**AGENDA  
CITY OF CEDAR FALLS, IOWA  
PLANNING AND ZONING COMMISSION MEETING  
WEDNESDAY, NOVEMBER 10, 2021  
5:30 PM AT CITY HALL AND VIA VIDEO CONFERENCE**

TO: Planning & Zoning Commission
FROM: Chris Sevy, City Planner I
Ben Claypool, PhD, EI, Civil Engineer II
DATE: October 20, 2021
SUBJECT: Creekside Luxury Condos - Preliminary & Final Plats

**TO:** Planning and Zoning Commission  
**FROM:** Chris Sevy, City Planner I  
 Ben Claypool, PhD, EI, Civil Engineer II  
**DATE:** October 19, 2021  
**SUBJECT:** Site Plan – Creekside Condos

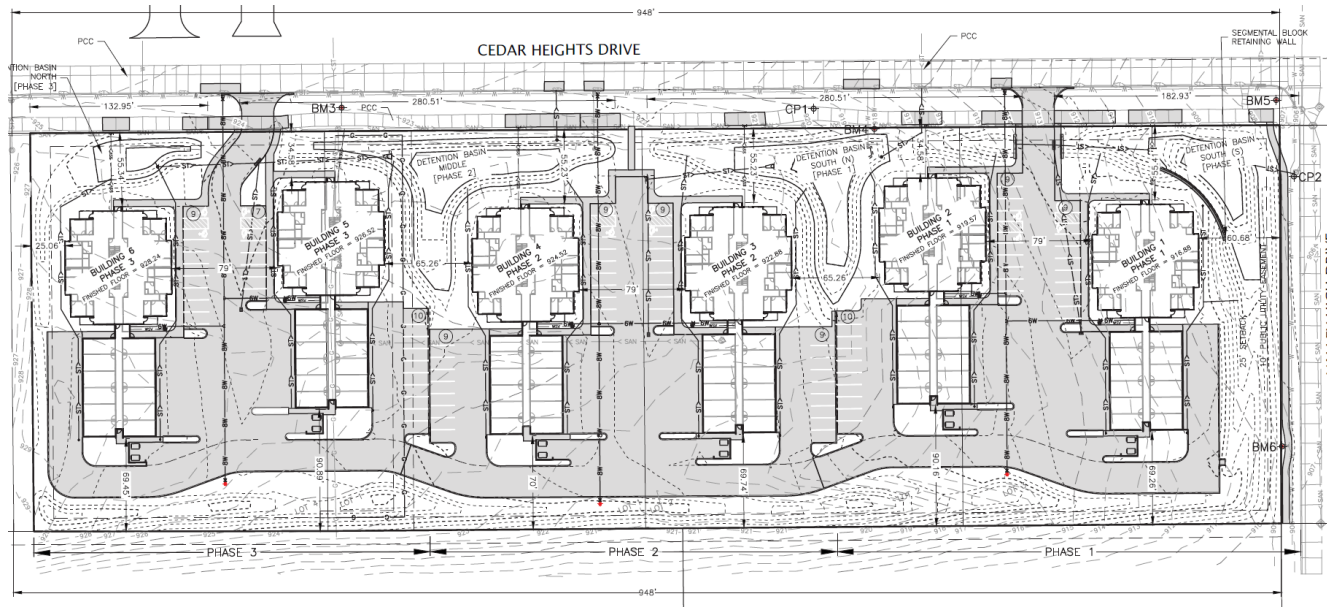
Below is the development site plan provided by the applicant featuring six 12-plex buildings, attached garages, and additional parking (See also full site plan set attached). Also detailed is the stormwater management infrastructure planned for the site.

Concern about the height and number of units has been expressed by members of the neighboring HOA to the west. The applicant seems to adequately address these concerns by providing a substantial buffer that more than meets the landscape requirements, and having the buildings set back a minimum of 69 feet. The buildings at that setback are only 1 story and the 3-story 42-foot structures are 170 feet minimum from the west property line. Both of these measures are substantial by general privacy standards in the City. The submitted site plan is consistent with the master plan submitted with the rezoning.

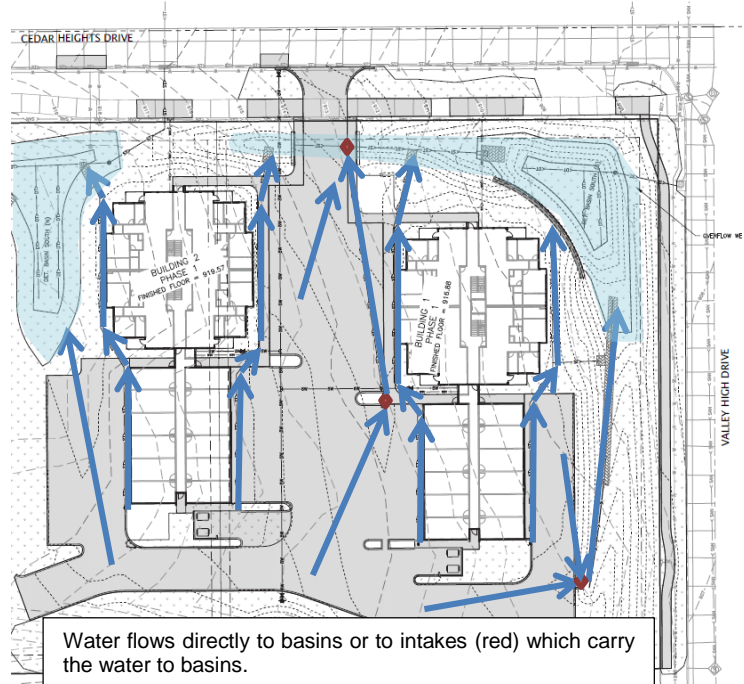
- Below is the provided landscape plan (see attached detailed landscaping plan). This plan shows the necessary screening of parking areas along property lines and street frontages as previously discussed. The parking code also requires trees in the interior of the parking area at the rate of 1 per 21 parking spaces which comes to 8 overstory trees required to give shade to parking spaces. The applicant provides two trees in each parking area between buildings which comes to a total of 10 internal trees. In addition to these, there are other trees dispersed in spaces that make sense to beautify and provide variety around paved areas. Trees are also required around the periphery of the parking area (including street trees) at the rate of 1 per 50 lineal feet of parking area. The landscape plan more than meets this requirement when considering all of the overstory, ornamental, and coniferous trees provided. The landscaping plan provides the necessary details on species, planting size, and height at maturity. Staff finds this detailed plan is consistent with what was discussed at rezoning with regard to buffering along the west property line and adds additional detail on parking lot landscaping and landscape buffer along the north and south lot lines as well.

- Phasing is also noted on the above landscape plan which shows the southernmost buildings built first (on the right). Installation of the public sidewalk along the South border will be part of phase 1. Construction will progress northward (to the left), two

buildings at a time as market conditions demand. This is consistent with the phasing outlined in the developmental procedures agreement entered into in conjunction with the rezoning. This phasing also ensures a seamless rollout of the stormwater management plan where the largest portion of the infrastructure is taken care of in the first phase.

DRAWING: LANDSCAPING PLAN - ALL PHASES

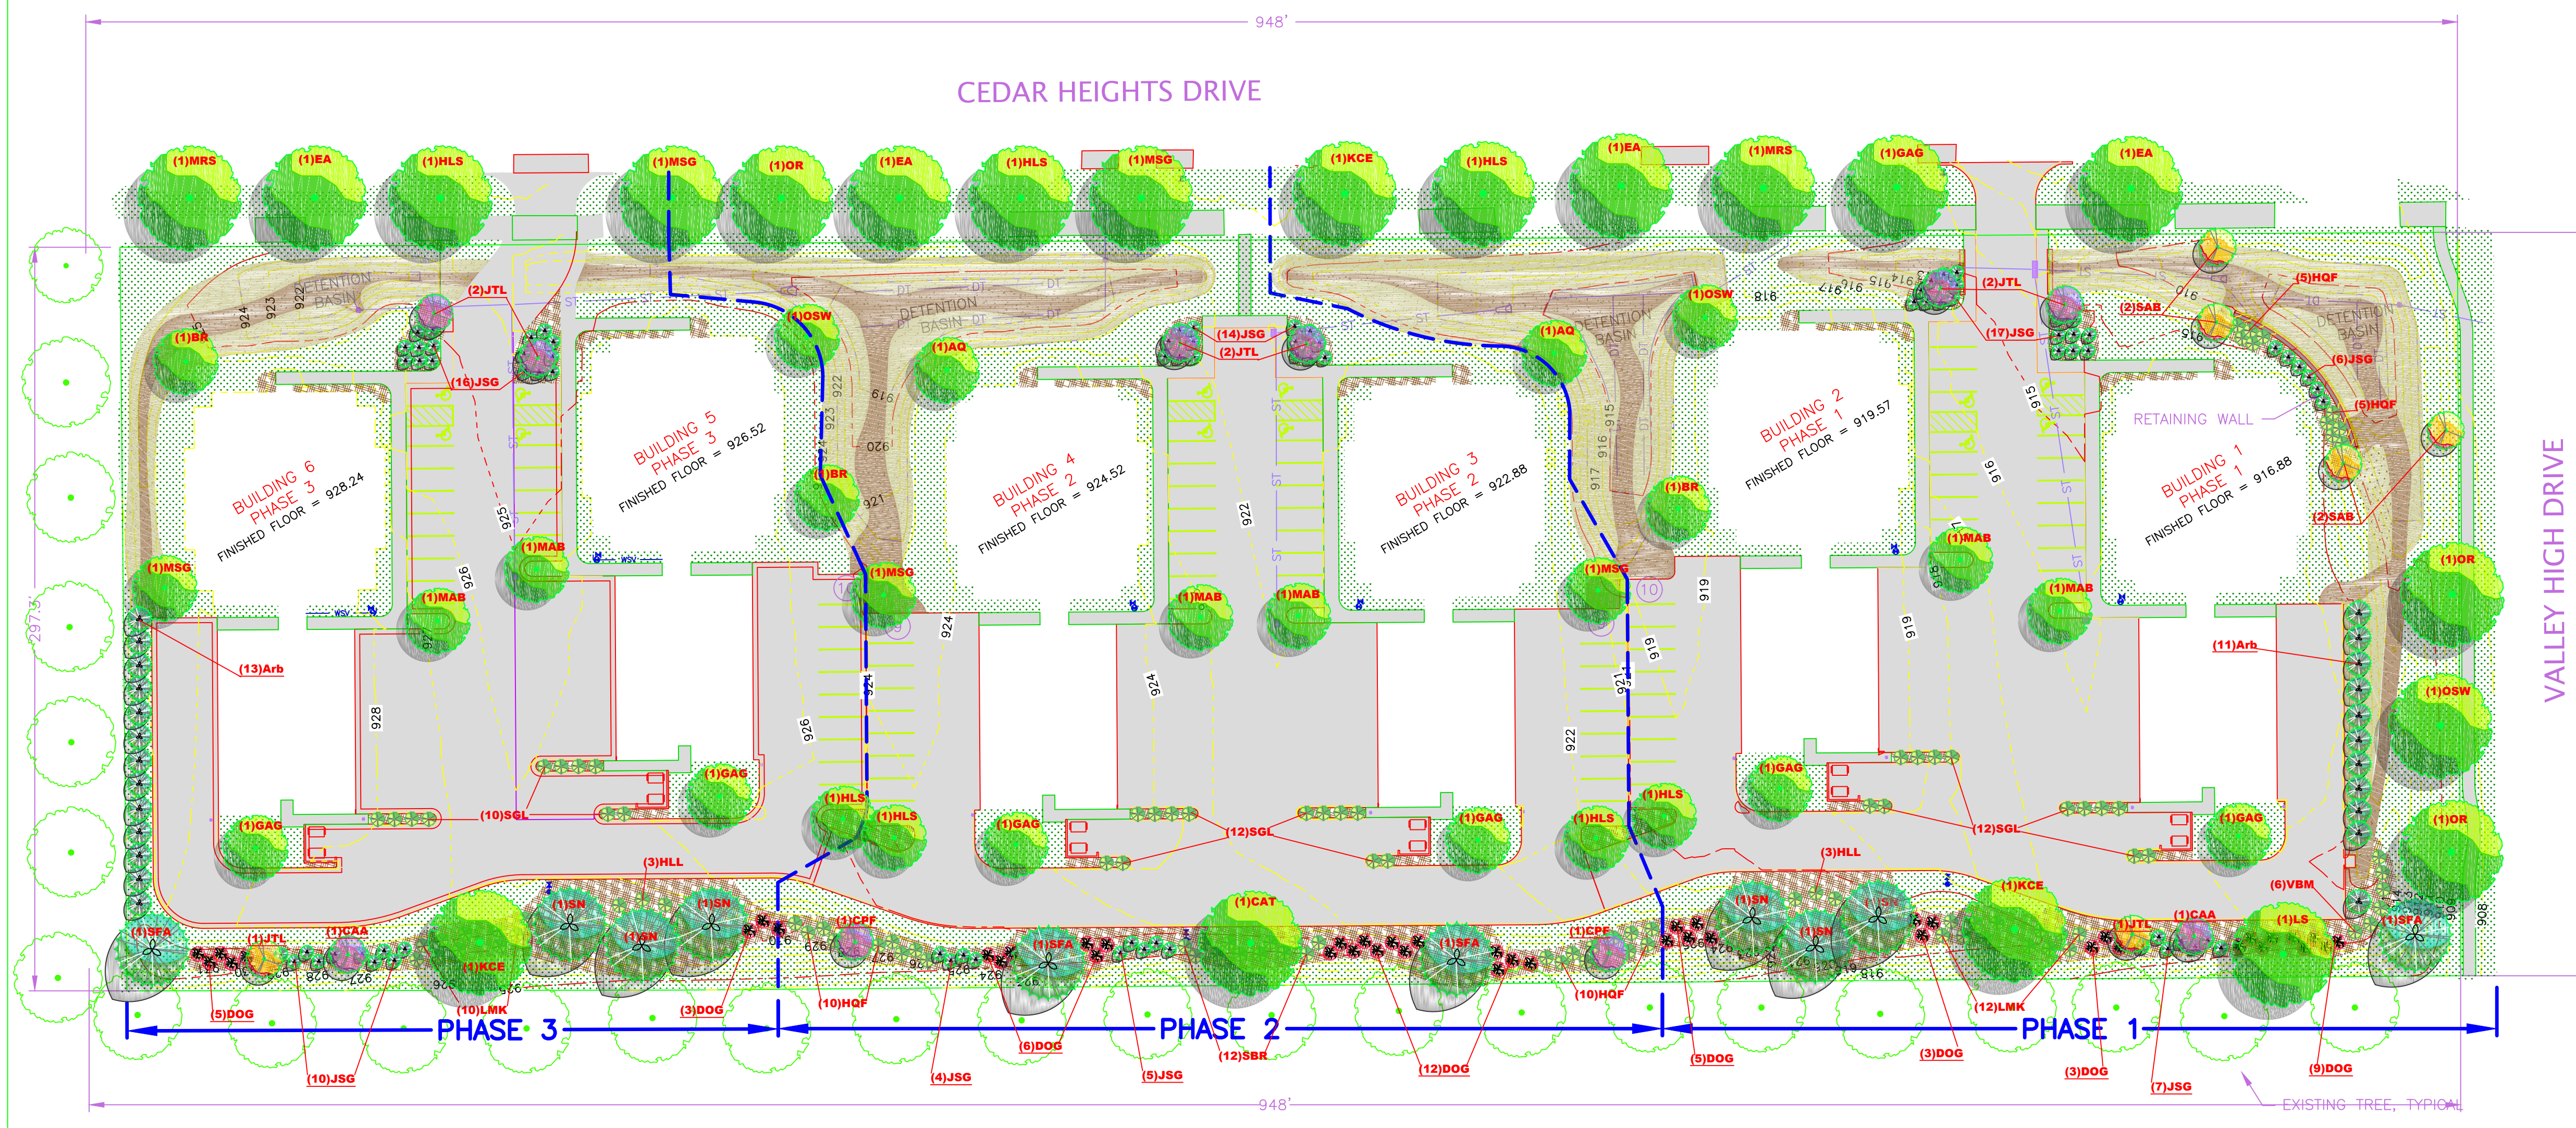
3. The landscape plan is substantially similar to the landscape plan that was filed with the master plan, but has been improved to ensure proper screening of the parking and that the interior of the parking lot has shade trees as required by code. Parking lot screening at the height of 6 feet is required along property lines abutting neighbors and 3 feet for parking areas that are in view of street frontages. The proposed plan features a 3.5 to 6-foot berm along the west edge of the property with trees, shrubs, and other plants on top of it which are required to have a height of 3 feet at planting. Below is an exhibit that was created to demonstrate to the neighbors how these measures will soften the view from their rear yards and effectively screen the taller buildings from view. Staff finds that this is a good solution to help screen and separate the lower intensity residential development to the west and the taller buildings proposed with this development.

The proposed plan also provides a 6-foot high screen of the parking along the north and a 3-foot screen at appropriate places along Cedar Heights Drive and Valley High Drive. Staff finds that the proposed landscape plan provides sufficient screening.

The landscaping plan shows trees and other landscaping features in the right of way and utility easements. Removal and replacement of the trees or any other landscaping located within these areas that may be disturbed by utility maintenance, repair, or replacement is the responsibility of the property owner.
